SUFFOLK COUNTY PLANNING COMMISSION

Notice of Meeting

June 1, 2016 at 2:00 p.m.

STAFF REPORT

Applicant: Riverhead Plaza Multiplex Cinemas
Municipality: Riverhead
Location: s/w corner of Old Country Road (CR 58) and Oliver Street (unopened)

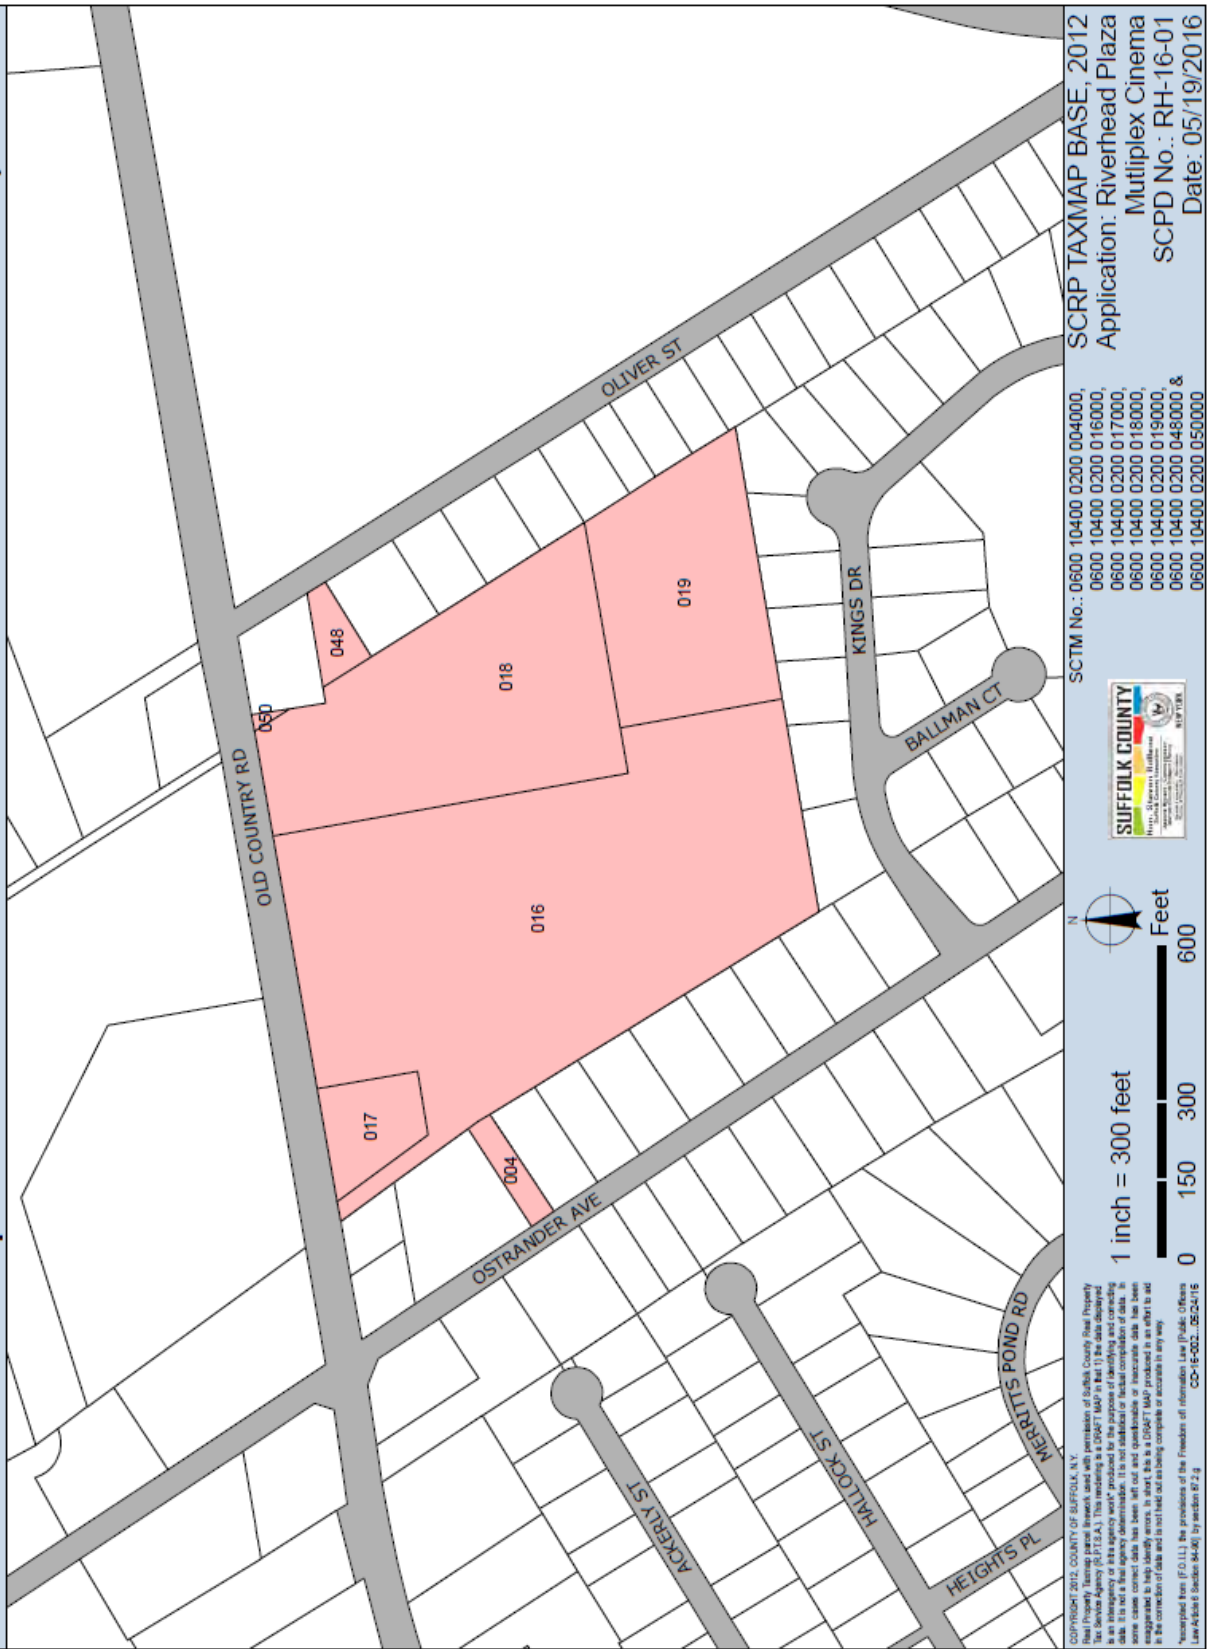
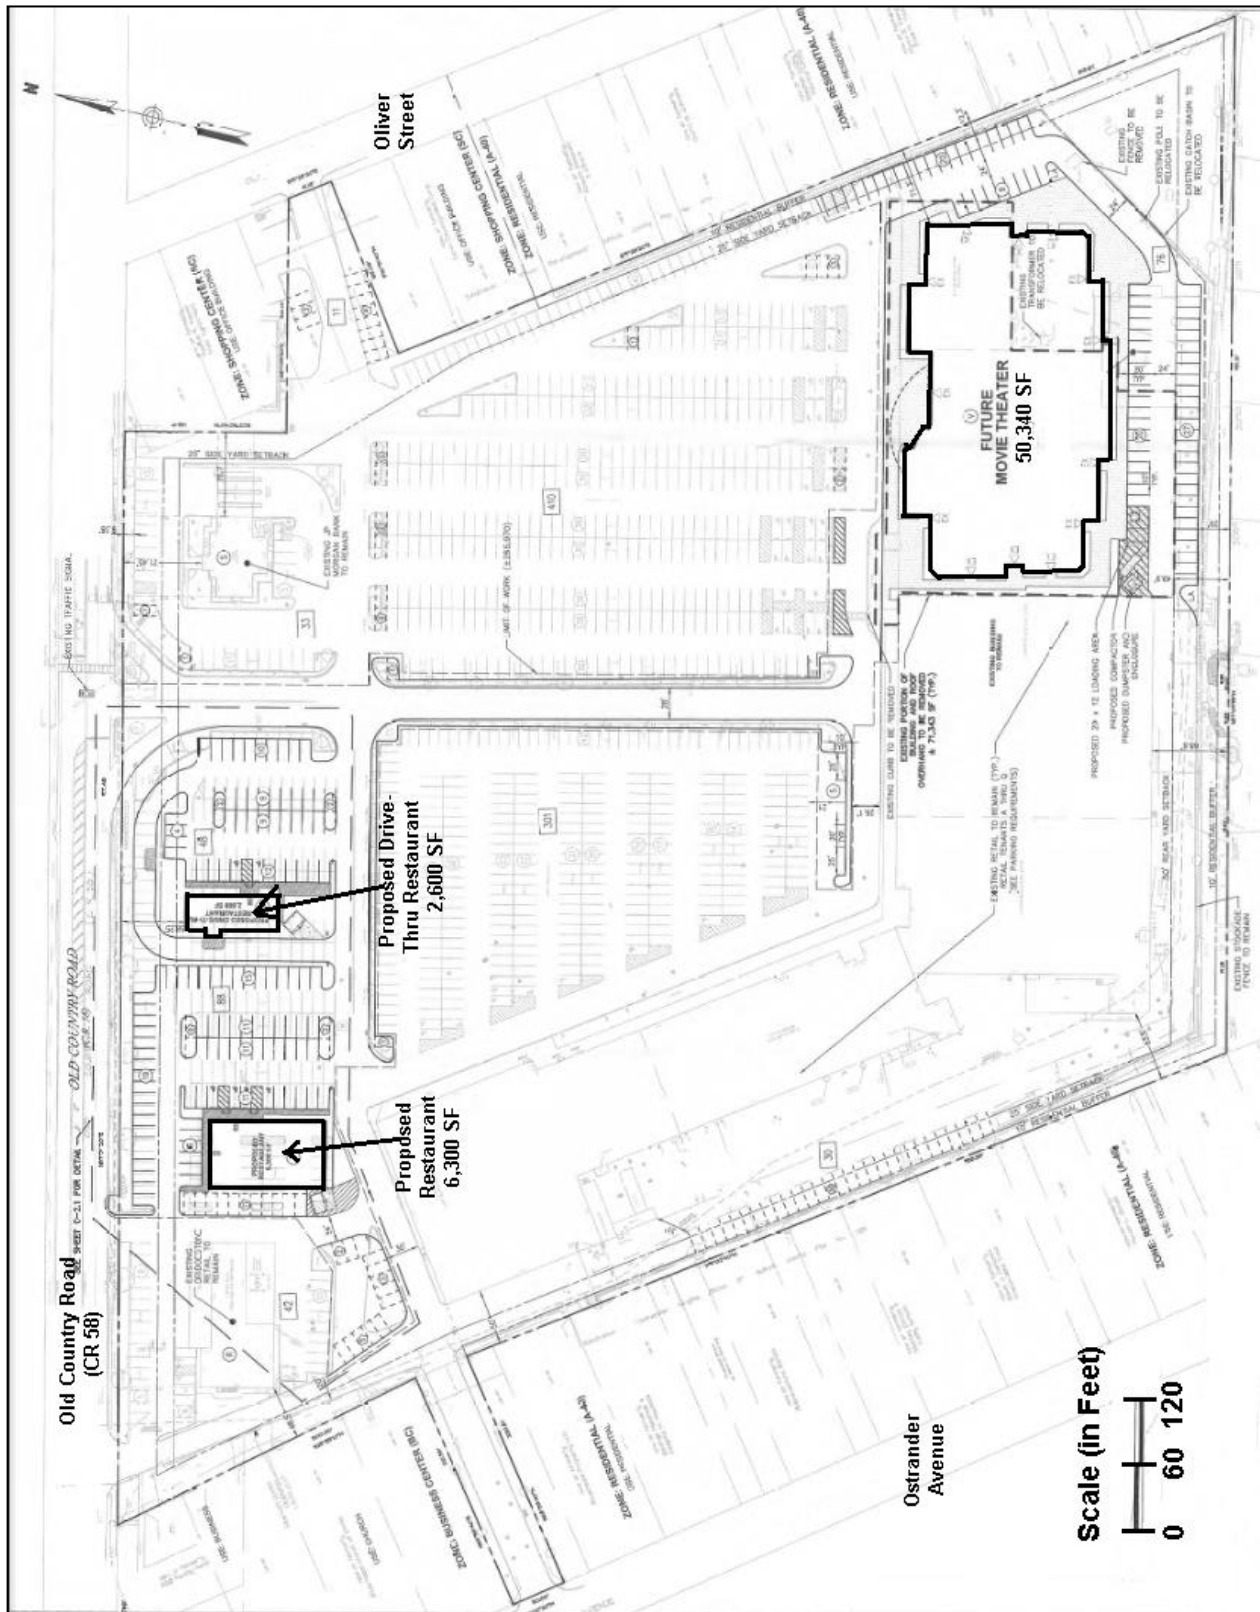
The existing square footage of building area on site, according to submitted materials to the Suffolk County Planning Commission by the Town of Riverhead Planning Board is approximately 211,190 square feet. Approximately 71,343 SF of existing building is to be removed and approximately 59,240 SF is to be constructed. Add to that all other altered areas (clearing, grading, disturbance, landscaping etc.) and the total square footage of altered area is 203,400 SF. The proposed development has less square footage in use than the prior Shopping Center at full occupation.

Dialogue should continue as is necessary for permits and approvals with the Suffolk County Department of Health Services and the Town of Riverhead Sewer District regarding waste water treatment and connection to the Riverhead Sewer District to the south.

There is no indication in the referred material that the project sponsors have given significant consideration, at this time, related to energy efficiency. The petitioners should review the Suffolk County Planning Commission Guidebook with respect to energy efficiency.

The “Shopping Center” nature of this proposal warrants that the applicants contact the Suffolk County DPW Transit Division, and investigate possible accommodations for bus riders.

There is no discussion in the referral material related to public safety. The petitioners should review the Suffolk County Planning Commission Guidebook particularly with respect to public safety. Moreover, internal access/circulation aisles appear to be unsafe for pedestrians traversing from parking lots to the entrance of the buildings. If possible, the access aisles should be designed to accommodate pedestrian crosswalks and amenities that assure safe walking movements.

Approval of the Riverhead Plaza (PGC) Multiplex Cinema site plan with the following comments:

1. Dialogue should continue as is necessary for permits and approvals with the Suffolk County Department of Health Services and the Town of Riverhead Sewer District regarding waste water connection to the Town of Riverhead Sewage Treatment Plant.
2. The applicant should review the Suffolk County Planning Commission publication entitled Managing Stormwater-Natural Vegetation and Green Methodologies.
3. The applicant should review the Suffolk County Planning Commission Guidebook particularly with respect to energy efficiency.
4. The applicant should contact the Suffolk County DPW Transit Division, and investigate possible accommodations for bus riders.
5. The applicant should review the Suffolk County Planning Commission Guidebook particularly with respect to public safety.
6. Internal access/circulation aisles appear to be unsafe for pedestrians traversing from parking

Canoe Place Inn Site Plan - Addendum - June 1, 2016

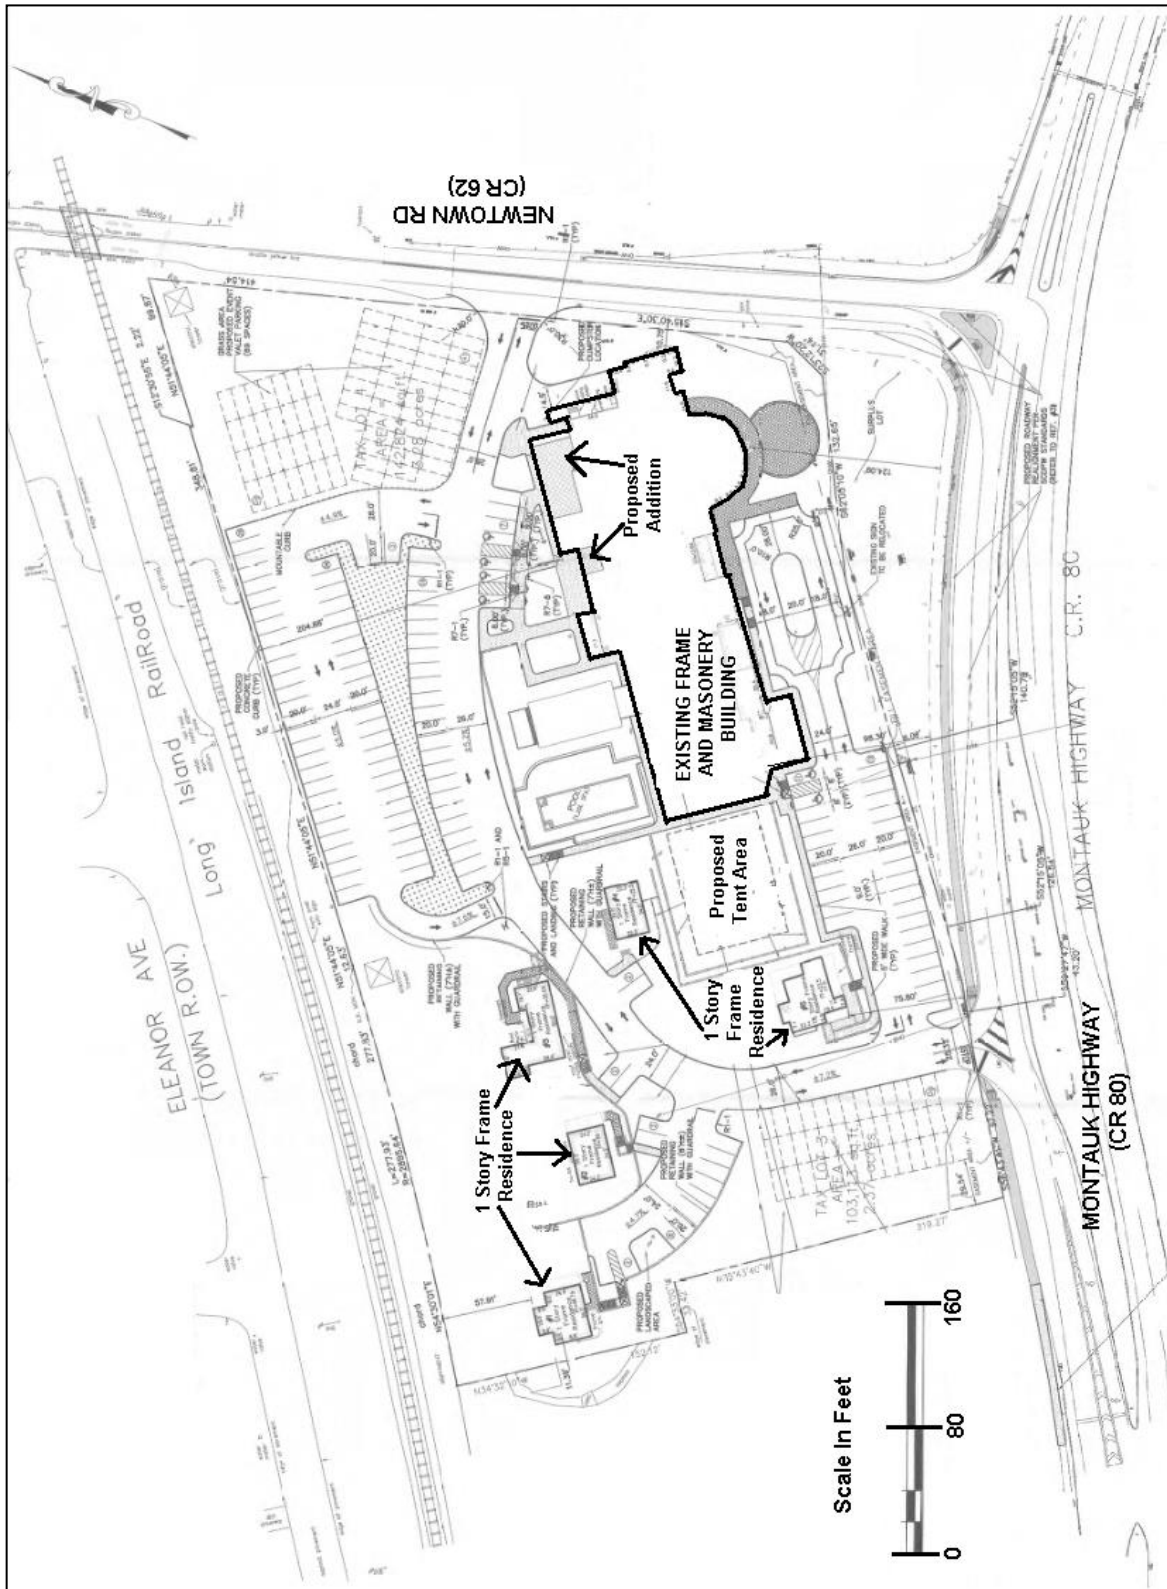
3. It is noted that a drainage reserve area, located at the southern end of the Canal Property, is a large depression set in the grade that will capture and recharge a portion of the storm water runoff into the surrounding soil. Low points situated throughout the site are intended to collect storm water runoff and direct it into the recharge system. The petitioners should be encouraged to review the Suffolk County Planning Commission publication on *Managing Stormwater-Natural Vegetation and Green Methodologies* and incorporate into the proposal, where practical, additional design elements contained therein.

4. The most landward limit of tidal wetlands associated with the shoreline of the Shinnecock canal should be flagged in the field by a qualified expert, verified by the appropriate agencies, and noted as such, shown on all surveys, sketches, map, plans, etc. and all regulatory setbacks for disturbance and construction taken from said most landward limit.

5. There is no mention in the referral materials to the Suffolk County Planning Commission on the petitions compliance with the NYS Long Island Workforce Housing Act. It is noted that the residential component is a voluntary reduction in allowable yield however, it is not apparent that as part of a mixed use development, a lesser percentage than the maximum allowable floor area ratio is being proposed for the entire CPIMPDD and thus would exempt the project from the Act. This should be re-emphasized and further clarified or accommodation to the Housing Act should be made by the project sponsor.

6. No mention of the consideration of energy efficiency is provided in the referral material to the Suffolk County Planning Commission. The petitioners should be encouraged to review the Suffolk County Planning Commission Guidebook particularly with respect to energy efficiency and incorporate where practical, elements contained therein applicable for the commercial, residential and clubhouse components of the proposal.
7. The petitioners should review the Planning Commission guidelines particularly related to public safety and incorporate into the proposal, where practical, design elements contained therein.
8. The petitioners should review the Planning Commission guidelines particularly related to universal design and incorporate into the proposal, where practical, design elements contained therein.

Approval of the Canoe Place Inn, Site Plan with the following comments:

3. No mention of the consideration of energy efficiency is provided in the referral material to the Suffolk County Planning Commission. The petitioners should be encouraged to review the Suffolk County Planning Commission Guidebook particularly with respect to energy efficiency and incorporate where practical, elements contained therein applicable for the commercial, residential and clubhouse components of the proposal.

4. The petitioners should review the Planning Commission guidelines particularly related to public safety and incorporate into the proposal, where practical, design elements contained therein.

5. The petitioners should review the Planning Commission guidelines particularly related to universal design and incorporate into the proposal, where practical, design elements contained therein.
